Presentation from the Algonquins of Pikwàkanagàn First Nation

Canadian Nuclear Laboratories (CNL)

Application from the CNL to amend its Chalk River Laboratories site licence to authorize the construction of a near surface disposal facility

CNSC Public Hearing on the License
Application Review of CNL's
Proposed Near Surface Disposal
Facility

2. Proximity of the NSDF Project to the Kichi-Sìbì and lack of meaningful engagement of the AOPFN in Project planning and siting

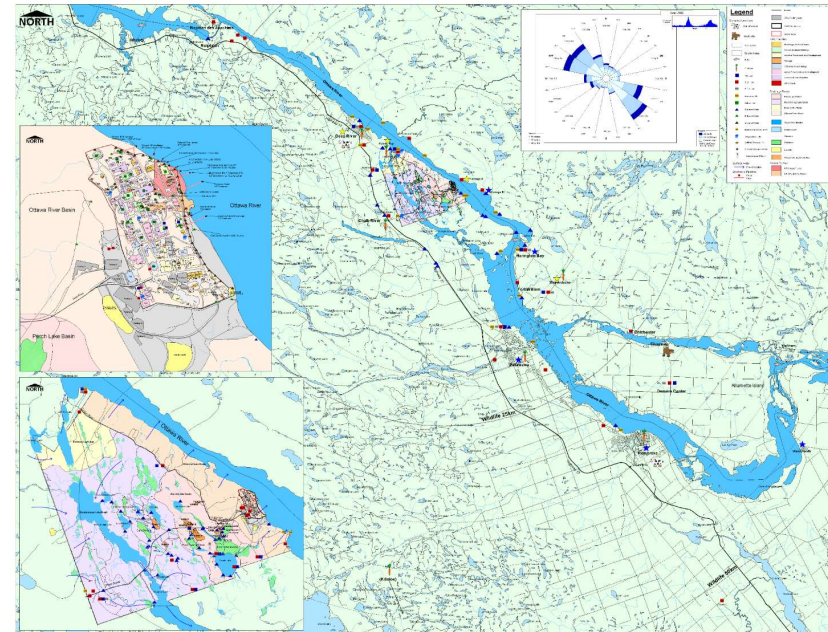
- The NSDF would be located within 1 km of Kichi-Sìbì. Our members have consistently raised concerns about this proximity with CNL and AECL, and about the lack of engagement of AOPFN in the consideration of alternative locations for permanent waste disposal, but no revisions have been made to the proposal as a result.

- AOPFN has never been engaged by AECL or CNL in site planning activities to date.
- **AOPFN Recommendation #4: CNSC require CNL to reconsider alternative locations and means of disposing of all LLW waste at the CRL site, including evidence that CNL meaningfully engaged Indigenous parties in this process, prior to approving of the current NSDF proposal.**

- **AOPFN Recommendation #5: AECL and CNL to engage AOPFN in a planning process regarding the desired end land use state for the CRL as a whole, prior to making determinations on where and how to permanently dispose of radioactive wastes currently at the site.**

4. Importation of radioactive waste into AOPFN territory for disposal at NSDF

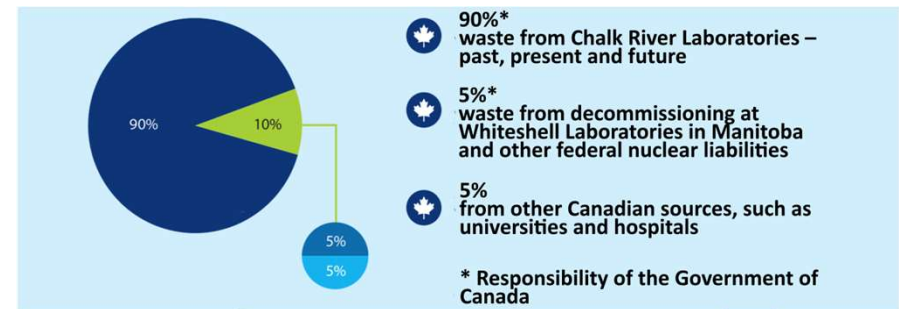
- However, CNL has also proposed to add as much as 10% of the total waste stream from off-site sources. This is as much as 100,000 cubic metres of waste imported into unceded AOPFN territory

- The importation of radioactive waste from other facilities, is opposed to the AOPFN's nuclear sector principles and the Anishinabek Nation and Iroquois Caucus (2017) *Declaration on Nuclear Wastes* which calls for “no imports or exports” of nuclear wastes

- The AOPFN does not accept the argument that bringing more wastes in will make conditions better at Chalk River Labs

- **AOPFN Recommendation #8: CNL proactively remove the 10% of potential “off-site” waste from its proposed NSDF waste stream.**
- **AOPFN Recommendation #9: CNL commit to not contemplate importing any wastes from outside AOPFN territory to the NSDF without written AOPFN permission.**

- **AOPFN Recommendation #10: If the CNSC issues permission for the NSDF to be developed, these permissions be made contingent on the 10% of off-site waste being removed from the NSDF Project stream. The CNSC should further identify that it will not allow for the importation of off-site wastes in any operations stage licence for the NSDF without evidence of Indigenous support for these off-site waste streams.**
